Invitation to Tender (ITT)  
Retail Store Renovation - Construction  
Reference #: NGC105749  
Buy and Sell Reference #: PW-15-00697227  
October 27, 2015

## ADDENDA # 2

PART OF REFLECTED CEILING PLAN A-05

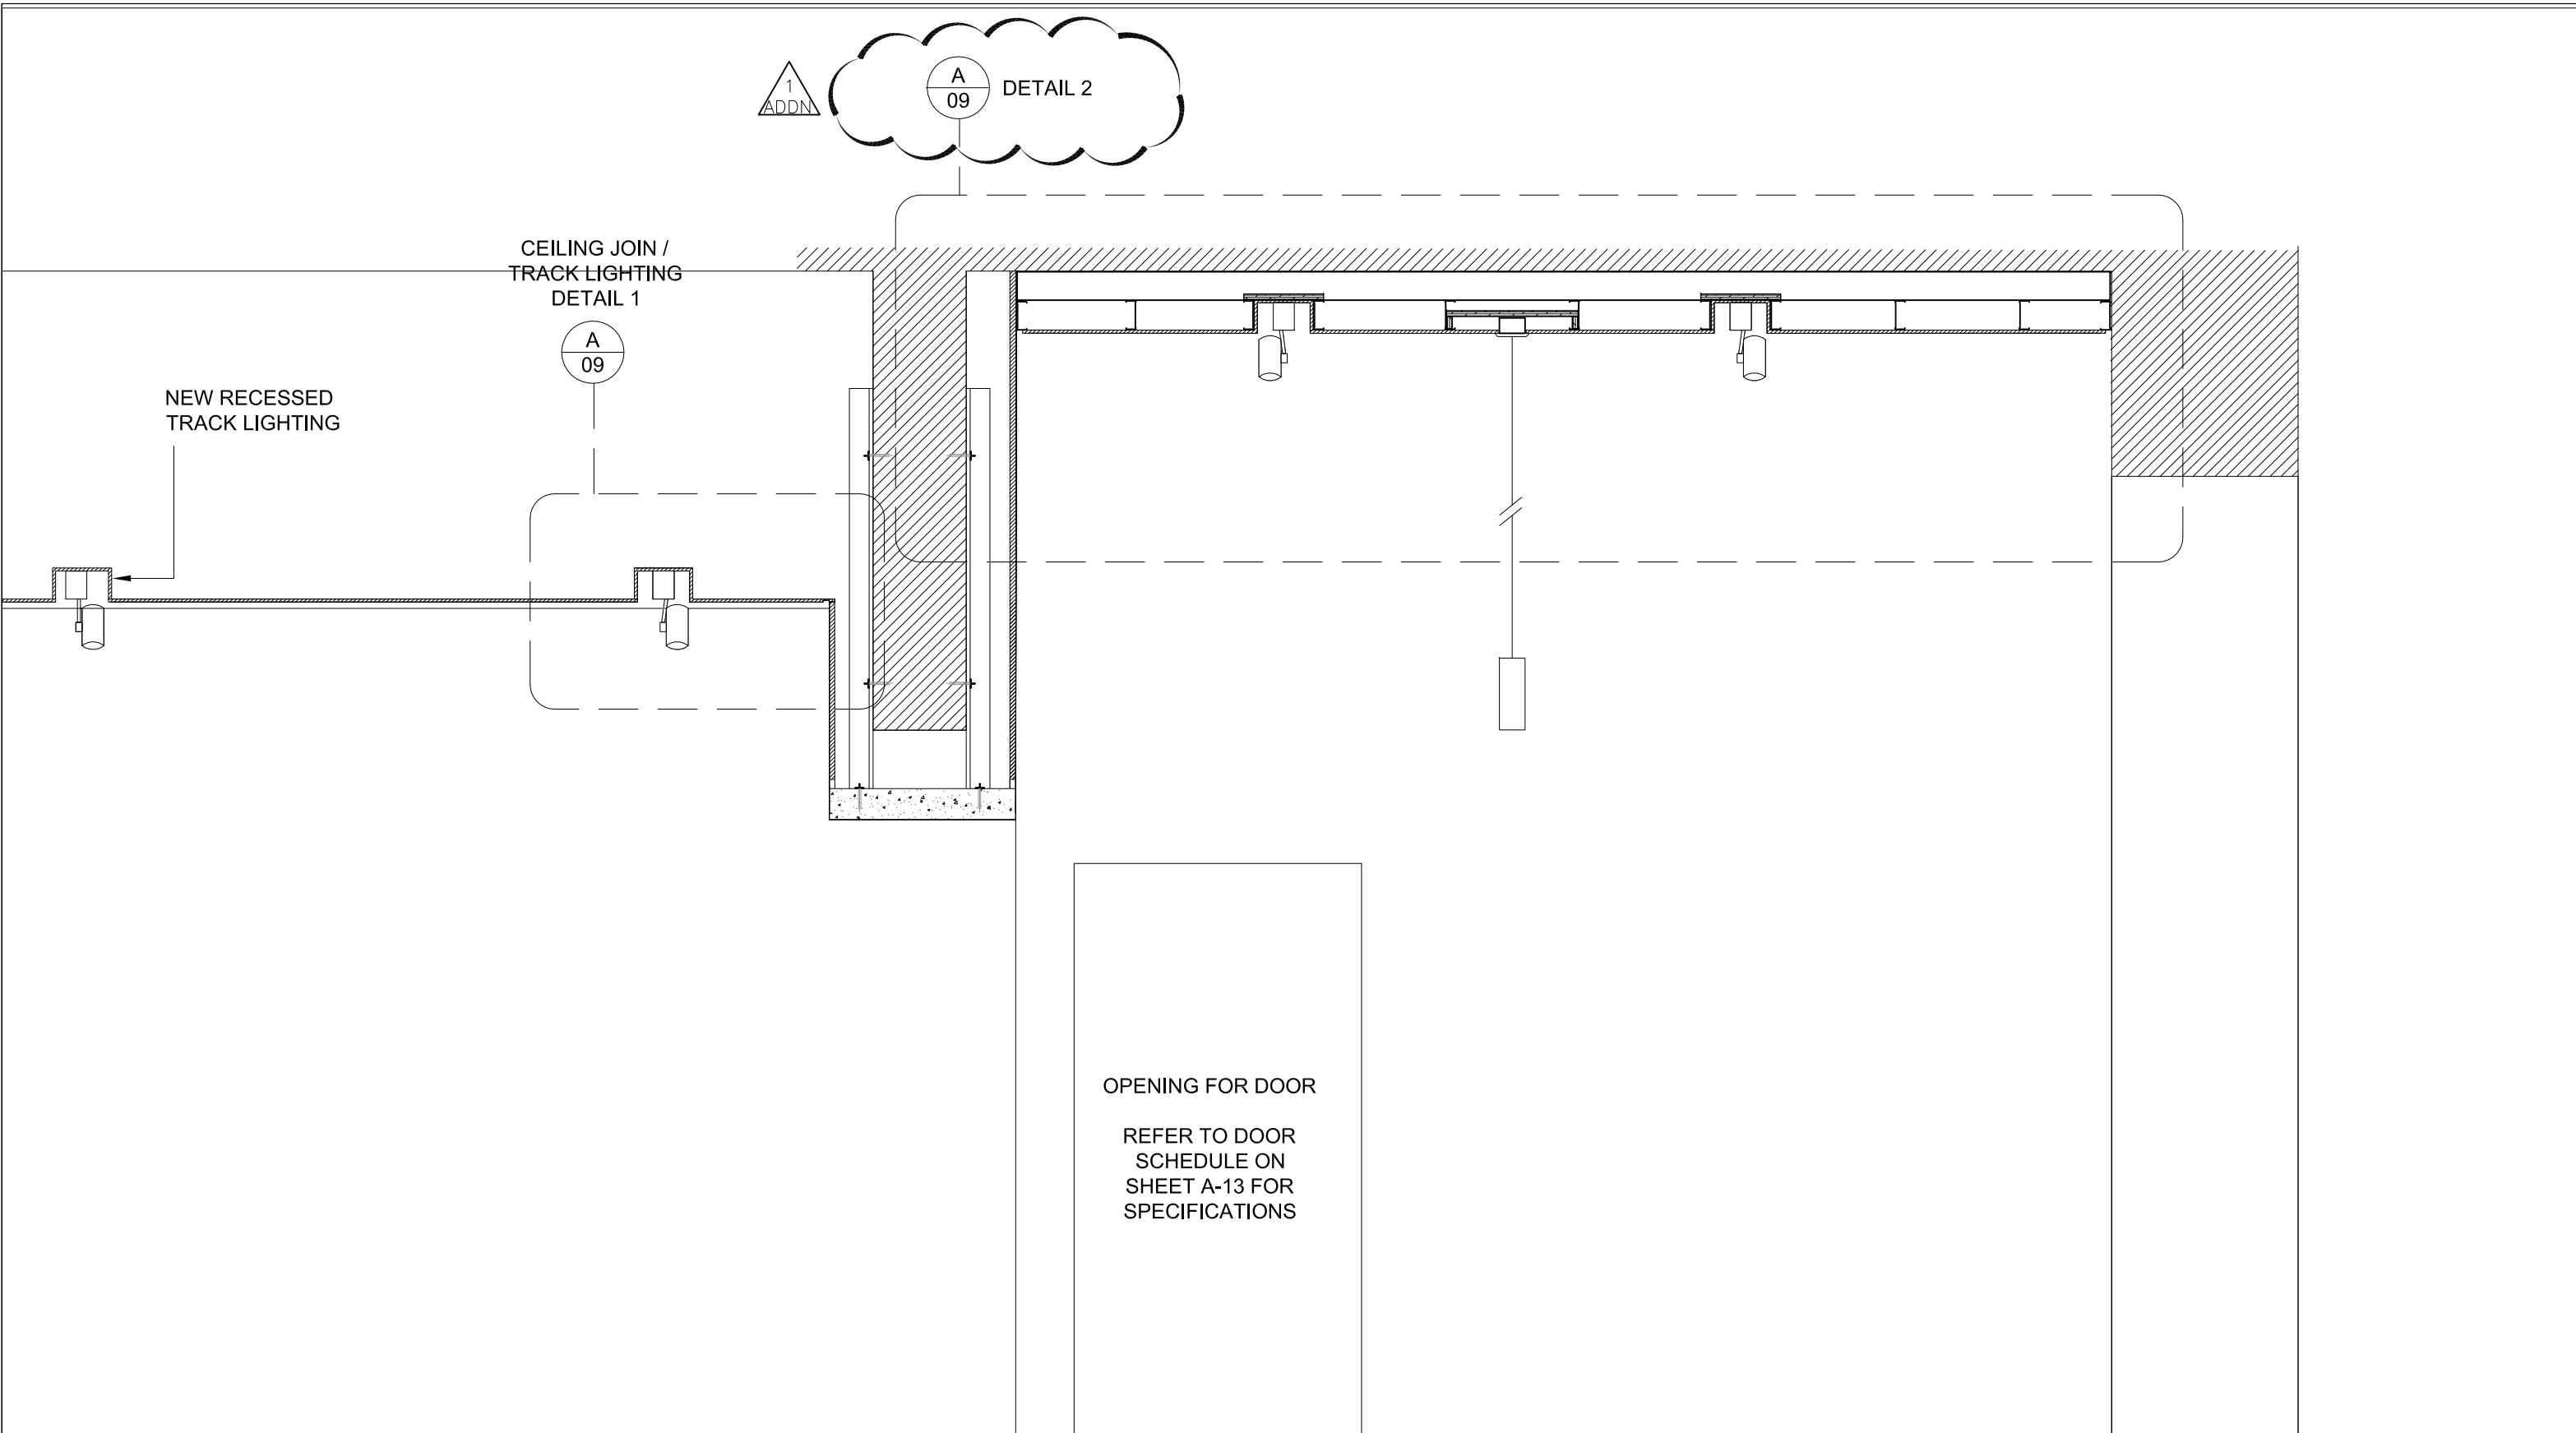
1. Reference: Drawing A-05 – REFLECTED CEILING PLAN  
Refer to attached sketch ADDN-A-05-01 for revised ceiling and lighting information in plan.
2. Reference: Drawing A-08 – INTERIOR ELEVATIONS  
Refer to attached sketch ADDN-A-08-01 for revised interior elevation information and added detail for gypsum board ceiling.
3. Reference: Drawing A-09 – INTERIOR ELEVATIONS  
Refer to attached sketch ADDN-A-09-01 for revised ceiling and lighting information in section.
